**Our Case Number:** ABP-313828-22

**Re:** Demolition of existing building and construction of 5 storey over partial basement mixed use development comprising gastro pub/restaurant with off-licence, 2 retail units, 50 apartments, parking and associated site development works.  
Lands at the Silver Granite pub, Palmerstown, Dublin 20

**Third Party planning appeal vs. the decision of South Dublin County Council made under planning application, reg. ref. SD21A/0271, to issue Notification of Intention to Grant Planning Permission for proposed development comprising of "Demolition of the existing building on site and the construction of a 5-storey over partial basement, mixed-use development comprising a gastro pub/restaurant with off-licence, 2 retail units, associated bin stores, bike stores, 1 ESB sub-station, all at ground floor level; a small plant room at basement level; a total of 50 apartments (25 one beds and 25 two beds) on the upper floors, all provided with private balconies/terraces; communal roof gardens; car parking; motorcycle parking; bicycle parking; landscaping and upgrades to public realm including upgrades to existing pedestrian crossing on Kennelsfort Road Upper;

Fig. 1: The Applicant's 'Site Location Map' showing site areas on two sides of Kennelsfort Rd, etc.

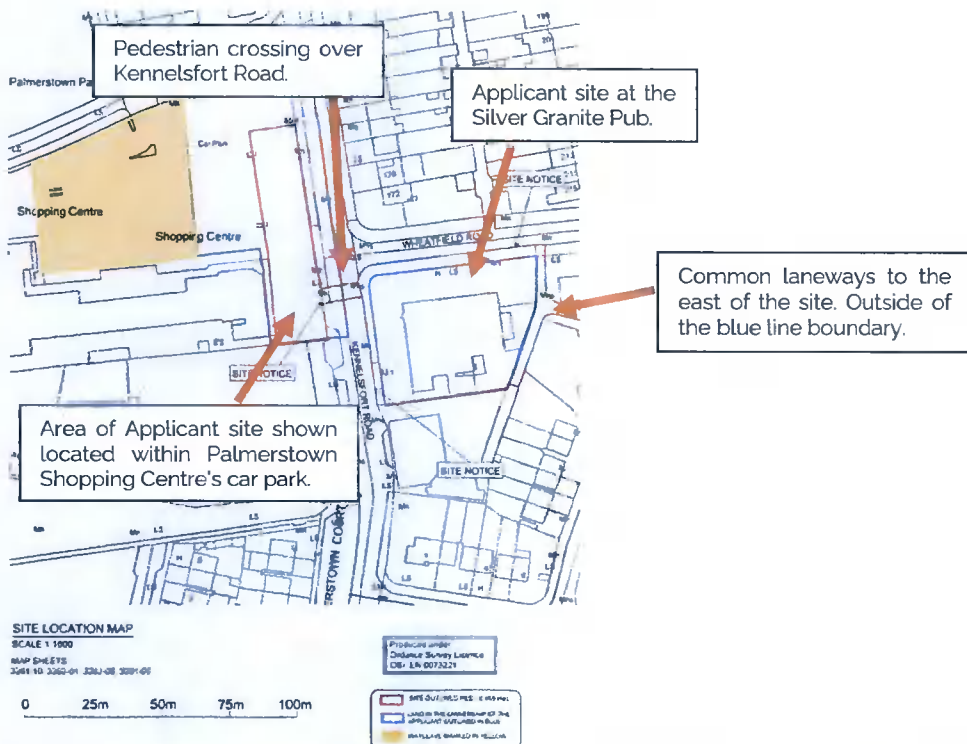
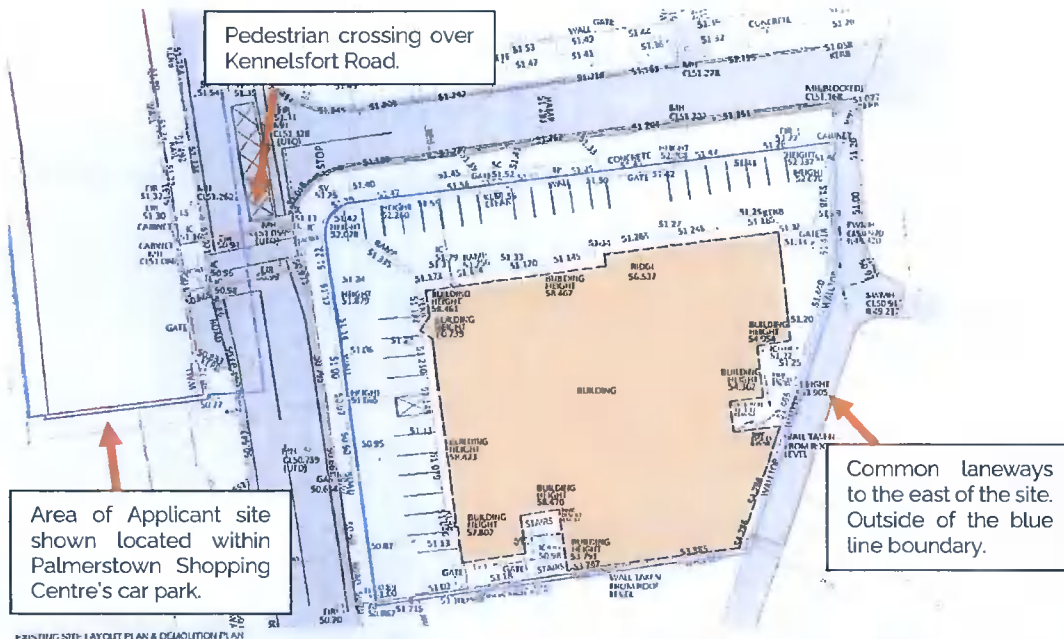
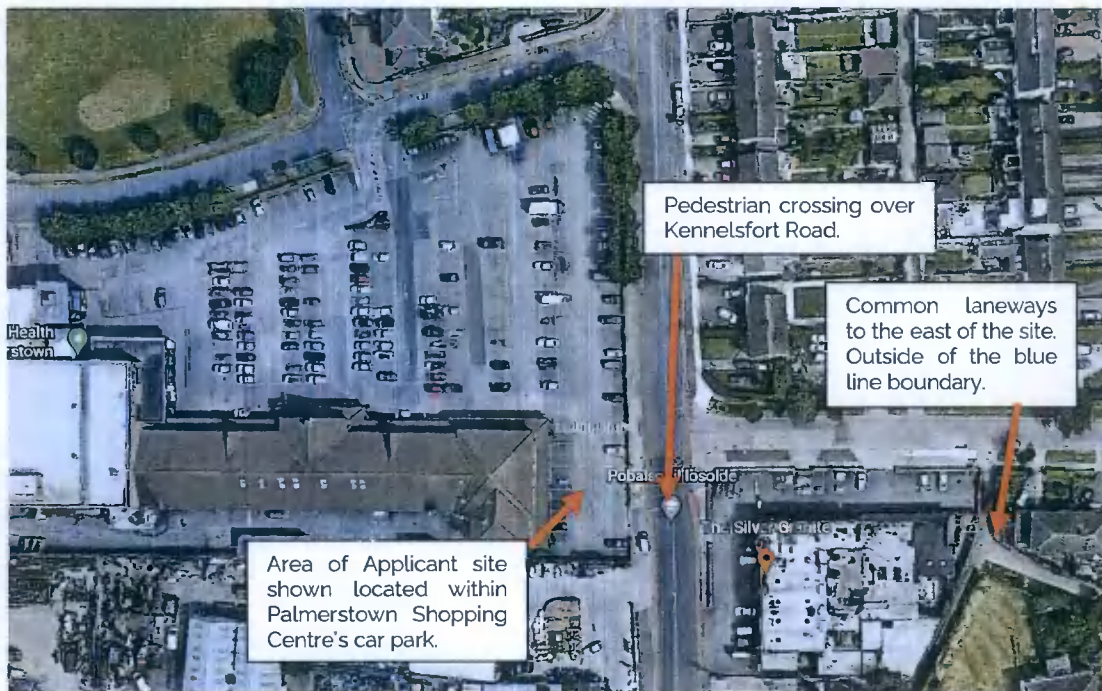
It is in fact the case that the Palmerstown Shopping Centre bears little physical or visual connection to The Silver Granite Pub. Kennelsfort Road, low height boundary walls and public footpaths all serve to disconnect these two commercial properties (see Figs. 1 to 6).

**Fig. 10: Existing location of emergency exit proposed to be closed off by the Applicant scheme (1)**

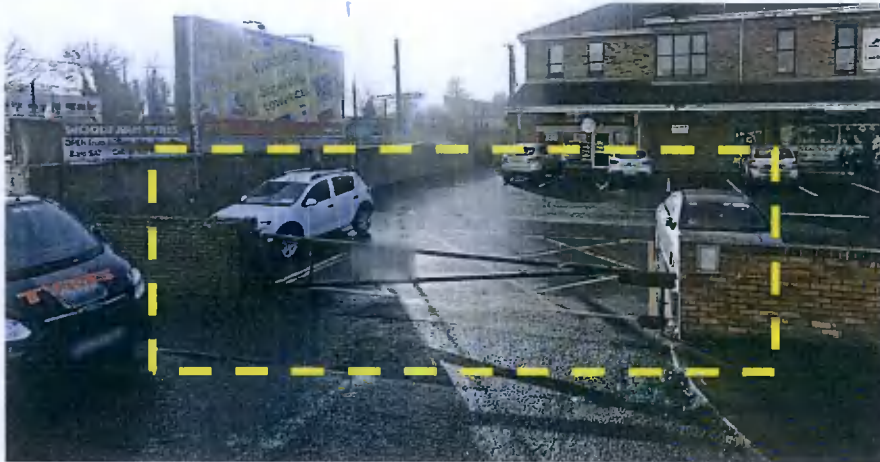
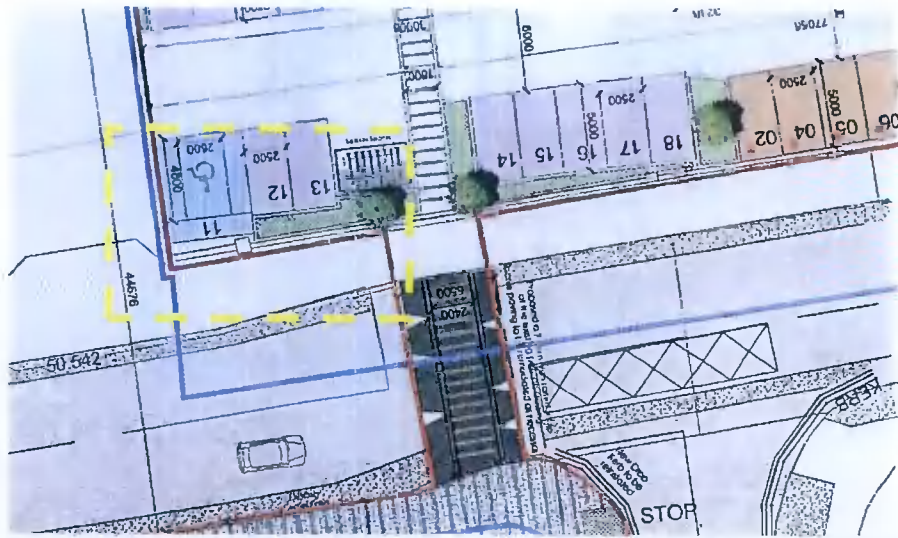
3. The FI stage proposals confirm the entire removal of the emergency vehicular exit from the Palmerstown Shopping Centre which was constructed on foot of its own planning permissions. How can it possibly be acceptable for this scheme to remove a critical element of the safety plan for the shopping centre? How will emergency vehicles enter/exit the site if the main entrance is blocked for any reason? This planning decision made by SDCC contravenes previous planning permissions pertaining to the shopping centre and to which the Applicant raised no objection(s). The Applicant was then and remains fully aware that the emergency entrance/exit onto Kennelsfort Road from the shopping centre was granted planning permissions and was built in compliance with its planning permissions.

Fig. 13: Proposal for a revised pedestrian crossing over Kennelsfort Road

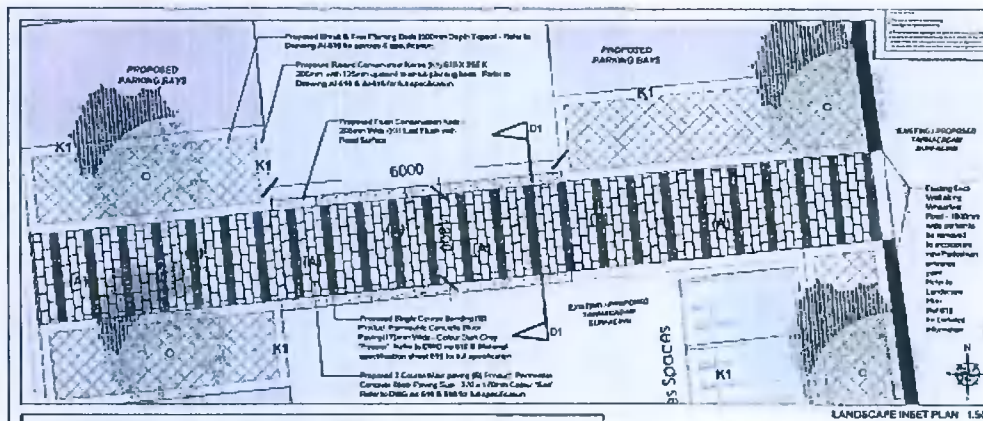
10. The Applicant FI stage proposals present a poor precedent for future developments adjoining shopping centres served by shared surface car parks to be carved up for use by individual developments in a manner which is contrary to the entirely rationale for a shared car park.
11. No details have been provided by the Applicant which show the demand for bicycle parking spaces at this location. This is not an attractive environment for cyclists. The Census provides details of the choice of commuting transport mode that households in given District Electoral Divisions use. The percentage in this area is likely to be very low and cycling cannot be forced on people especially those who do not own bikes.

**Fig. 18: Autotracking within the existing shopping centre's shared surface car park**

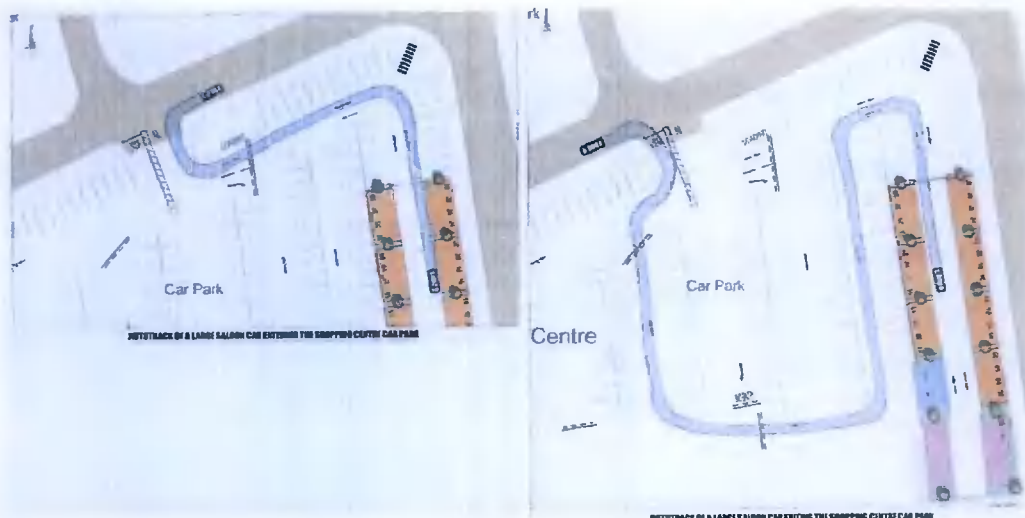
4. The Applicant's Autotracking for entering the proposed entrance into the fenced off area of shopping centre car parking uses a saloon car only. Our client does not believe that the largest vehicle would be a saloon car. What if this area is accessed by larger vehicles? Will this be safe for shopping centre pedestrians, etc? The Applicant shows a short and a long route through the shopping centre car park managed by our client but offers no agreement with the shopping centre's management that confirms this is acceptable. Our client disputes this proposal in full.

**Fig. 19: Public footpath and verge is subsumed into this scheme for parking, bike parking, etc.**

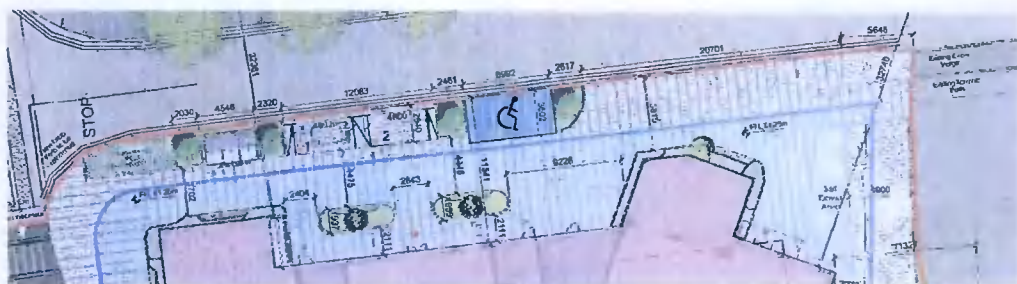
5. The Applicant continues to provide a disabled parking space, 2 standard parking spaces and bike parking within what is a public footpath and verge to the north of the site. Our client fails to understand how this is in any way acceptable. This matter is addressed fully in our client's attached Planning Objection Report.

**Fig. 22: The loading bay is shown as removed at FI stage but the area remains open to fly parking**

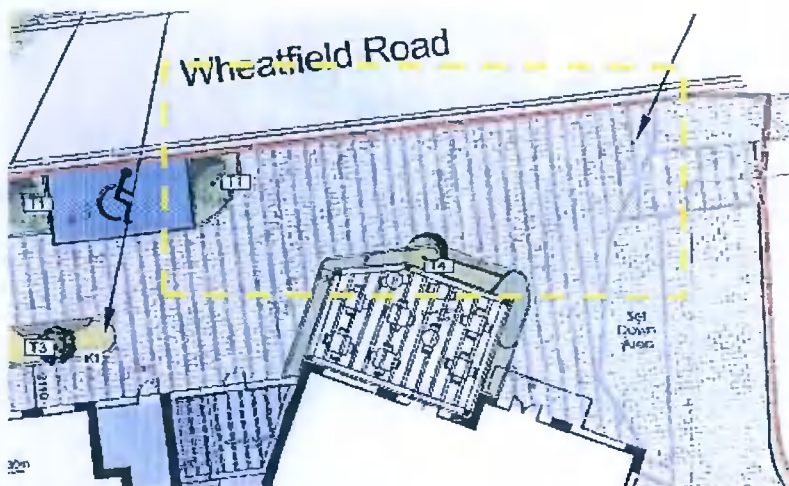
8. The proposed loading bay which was to be located in a public footpath has been removed but no satisfactory replacement is provided. The location of the loading bay is shown as an open area and would likely just be used as a loading bay anyway – it is finished in block paving (see Fig. 22). It is very unlikely that in practice delivery drivers, bin lorries and fire tenders would do anything more than park up on Wheatfield Road and/or on the kerb and carry out their deliveries, collect the bins, fight fires, etc. It is not credible to claim that such vehicles will enter the lanes to the east of the site – which requires the removal of bollards – drive in and then turn around. Such access and manoeuvring would take time which delivery drivers especially never seem to have. The proposals are inviting the creation of traffic hazards on Wheatfield Road.

**Fig. 23: Autotracking for the proposed bin lorries collecting from the site**

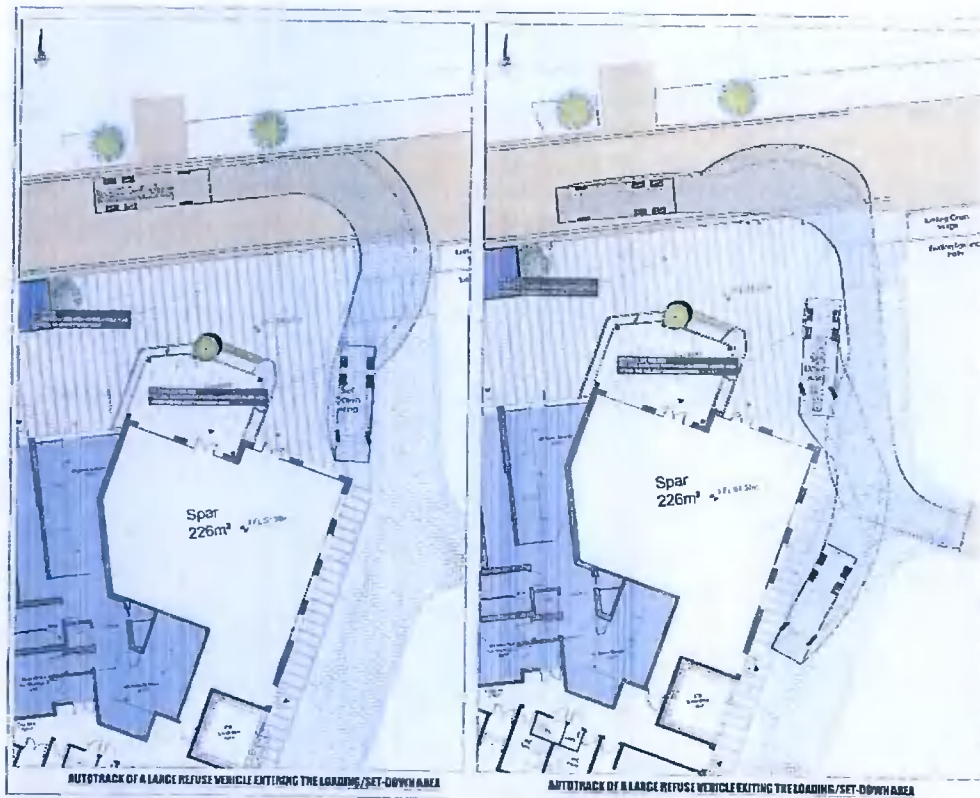
9. The Applicant's FI stage engineering submission argues that bins can be stored within the development area (red line boundary) on bin collection days without blocking pedestrian routes. In practice the bins would be placed on the footpath adjoining Wheatfield Road and would be collected from the road. Bin lorries do not make exceptions for some scheme.
10. SDCC required "A revised layout of not less than 1:100 scale, showing a suitable designated bin collection/delivery vehicle set-down spaces not on wheatfield Road or Kennelsfort Road, i.e., this should be located within the development". Our client cannot find these details in the Further Information submission. Bin collection proposals appear to continue to involve the use of public

areas which should be used as footpath and verge only or the use of the laneways to the east which are outside of the blue line boundary. This would mean the ongoing use permanently of the lane which is not an acceptable use of this lane as it is to serve a private scheme. Vehicles would need to turn in the laneways which could be being accessed by children, etc.

Fig. 24: Applicant public open space proposals appear to be private external drinking/dining areas?

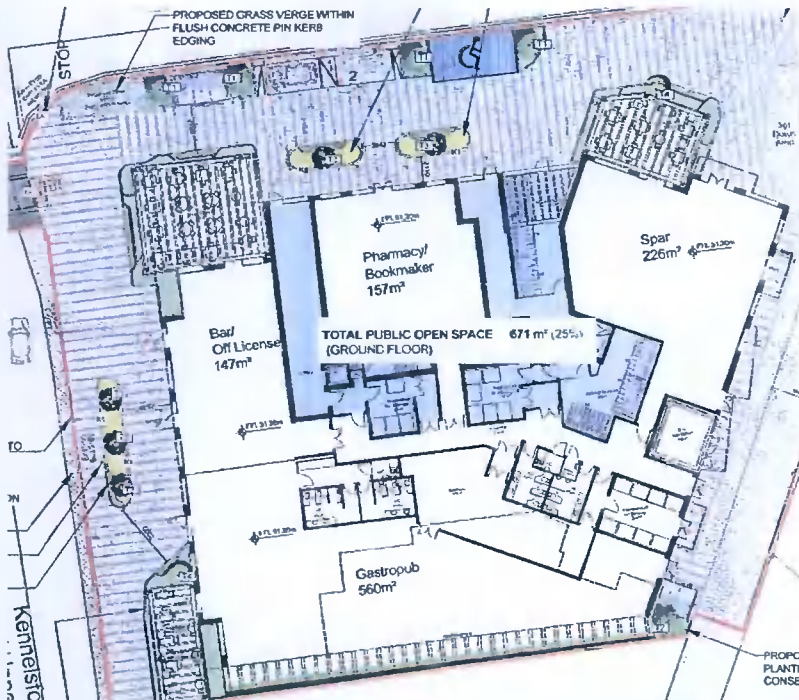
1. The Applicant claims that the FI stage scheme offers 671sq.m of public open space. BPS has carefully reviewed this planning application and we cannot find any space at ground level that could reasonably be referred to as public open space. The claimed spaces are privately managed drinking and dining spaces to be used by the Spar and the pub. Page 21 of the originally submitted Design Statement sets out how perimeter areas to the west and north of the proposed building – those currently used by The Silver Granite as its car park – are to be designated as public open space and communal open space. BPS has reviewed the proposed open spaces and we conclude that this provision confirms overdevelopment of this site.

3. To the west of the site:
  - The Applicant has added what is called a "semi-public seating area". With due respect, this area would be used by the "Gastropub" (as is acknowledged in a different part of the Design Statement – see Fig. 27) and very unlikely to be used by residents of the scheme.

Fig. 31: Map attached to the FI stage submission (1)

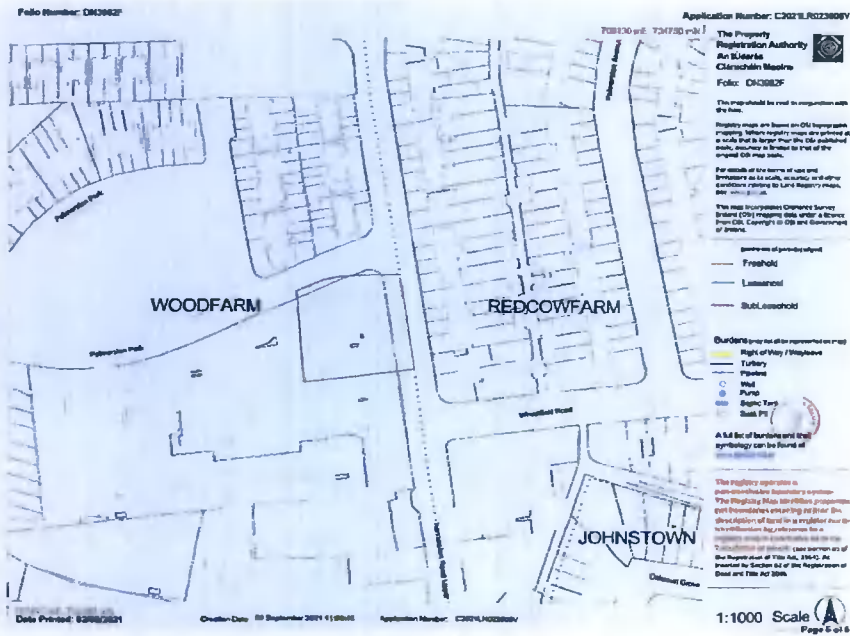
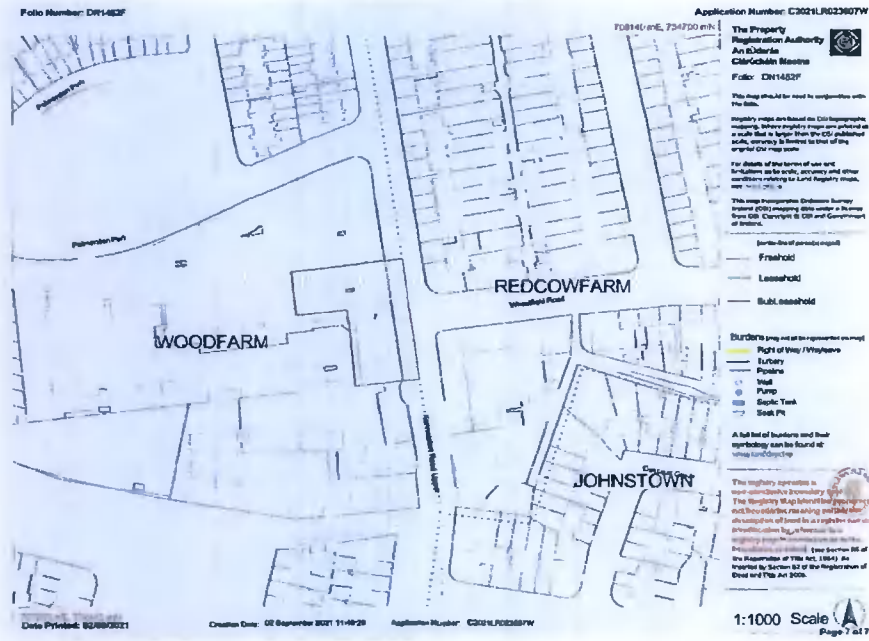
**Conclusion Item 5;** Our client considers the Applicant proposal regarding the existing shopping centre car park to verge on the bizarre. The planning application has come out of the blue and is at odds with over 30 years of constant use of the shopping centre car park in a shared manner. The proposed development cannot reasonably be permitted as currently proposed. The development proposals for the Palmerstown Shopping Centre's car park require permission from Palmerstown Shopping Centre Ltd. No such permission has been requested or provided. In the absence of same, it is difficult to envisage how the Applicant can have demonstrated sufficient legal interest to carry out the proposed development. Our client notes how Palmerstown Shopping Centre Ltd has managed the entire car park, including paying for all maintenance and upgrade works, over the past 30 years. The Applicant has contributed nothing.

**Fig. 33: Scheme's areas communal open space impact negatively on surrounding amenities**

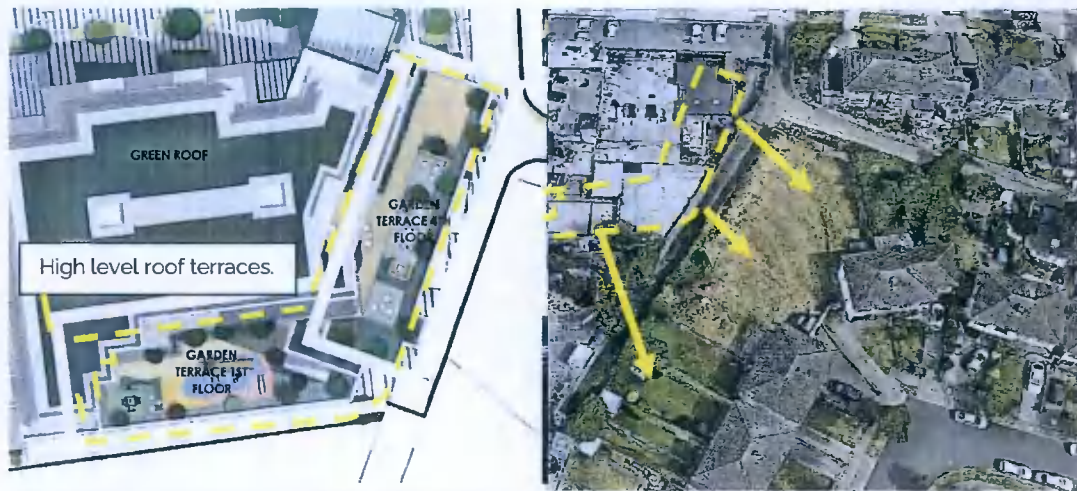
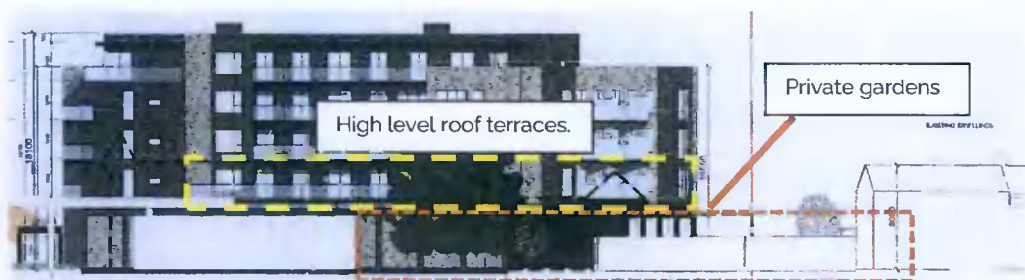
The Applicant has based their communal open strategy on hope that both SDCC and ABP will disregard these concerns in favour of this scheme. Our client submits that this is not acceptable. The proposed terraces would place the needs of the scheme developers above the right of residential property owners in the vicinity to be protected from overlooking, etc.

**Fig. 35: Scheme's communal open spaces impact negatively on future residents' amenities**

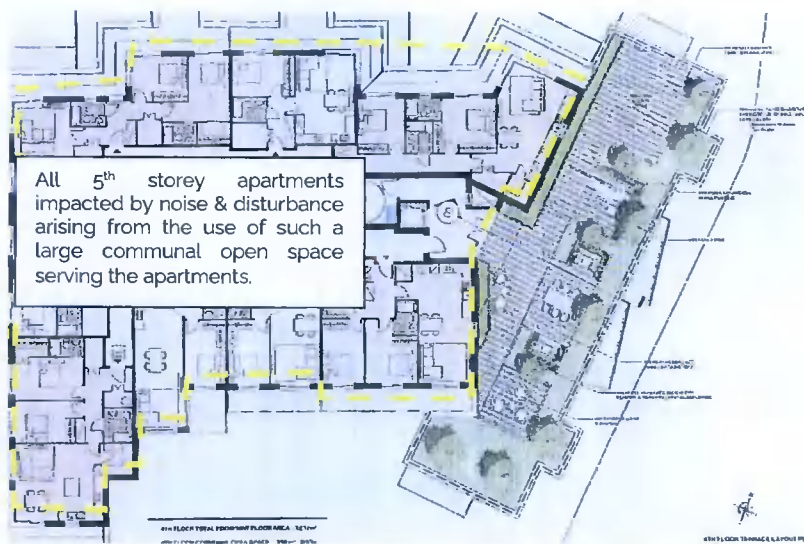
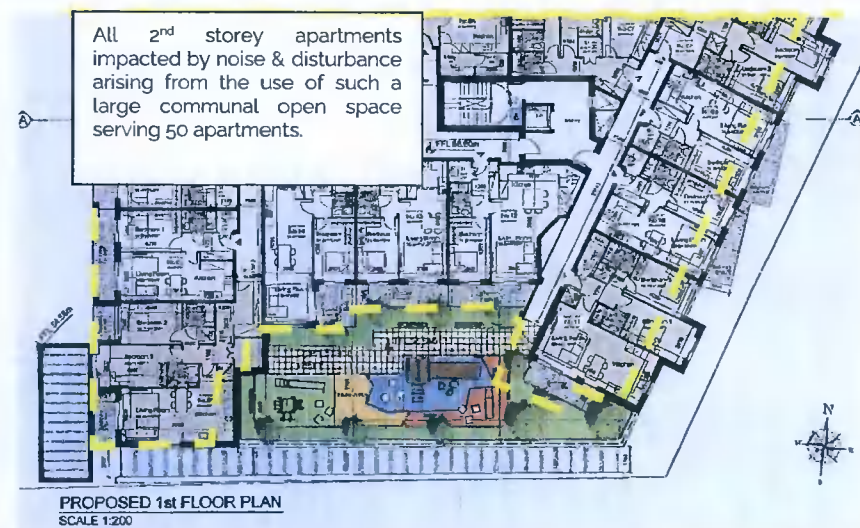
Our client submits that the proposed communal open spaces are not acceptable from a future amenity perspective for residents of the scheme. The scheme needs to offer improved public and communal open spaces for its residents. It may need to offer internal amenity areas.
